STAFF REPORT FOR THE PLANNING COMMISSION MEETING OF JANUARY 30, 2019

FILE NO: SUP-18-184

AGENDA TITLE: For Possible Action: To consider a request for a Special Use Permit to develop a portion of a parcel with an average slope of thirty three percent or more located on property zoned Single Family 1 Acre and located on the west side of Knoll Drive, APN 007-131-19 and -20. (Hope Sullivan, hsullivan@carson.org)

**KNOLL DRIVE
 SITE GRADING PROJECT
 CONSTRAINTS MAP**

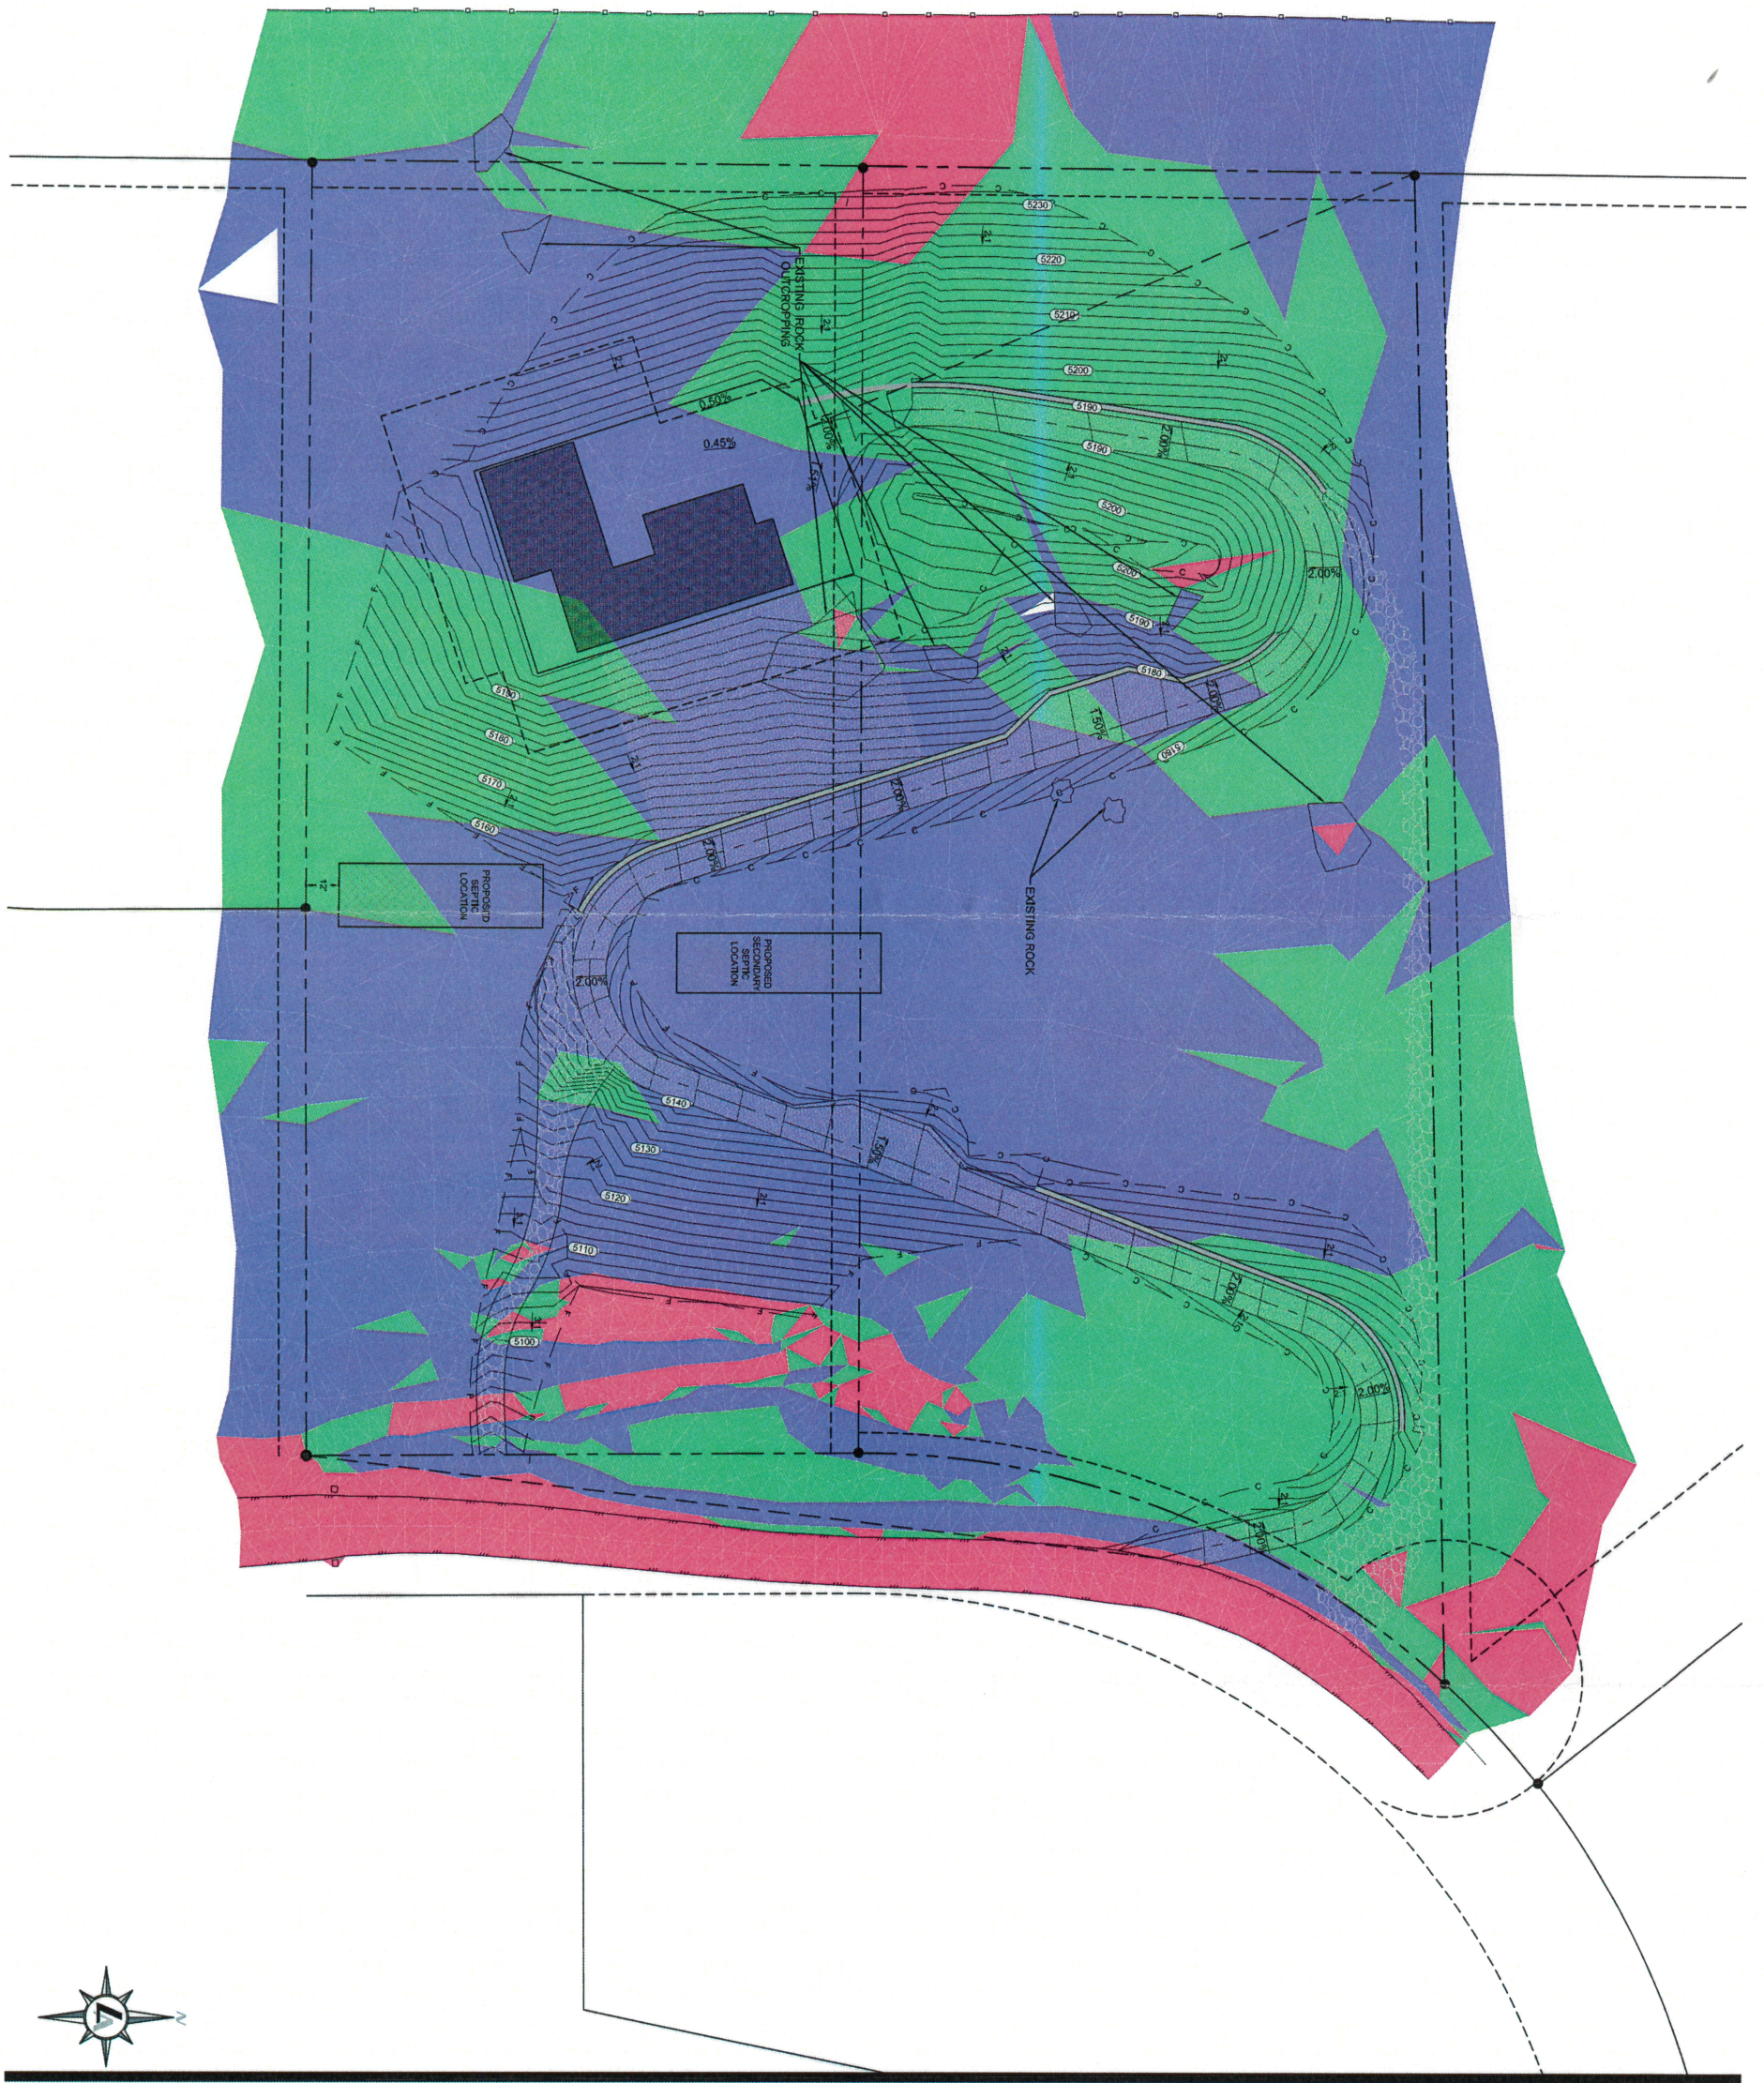
8. For steep ditches and swales, class 150 rip-rap must be used to prevent erosion. Native rock may be used instead of class 150 rip rap for ditches as long as native rock meets size requirements of class 150 rip rap.

9. The existing drainage channel along the frontage of Knoll Drive must be regraded and the driveway must have an appropriately sized culvert.
10. The plans for the site improvement permit must meet Carson City municipal code and development standards including CCDS Division 7 Hillside Development.

11. Cuts and fills must be rounded off in order to avoid the appearance of scarring.
12. Areas to not be disturbed during construction are to be fenced off during construction, with signs placed on the fences noting the purposed of the fence and advising that construction equipment is not permitted within the fenced areas.

The property is privately owned. By merging the properties, the development potential for hillside development will be reduced. Hillside Development standards apply when a parcel exhibits an average slope of fifteen percent or more. A slope analysis of the site demonstrates that most of the property is comprised of slopes in excess of fifteen percent. It is not possible to develop the site without developing on slopes that constitute hillside development.
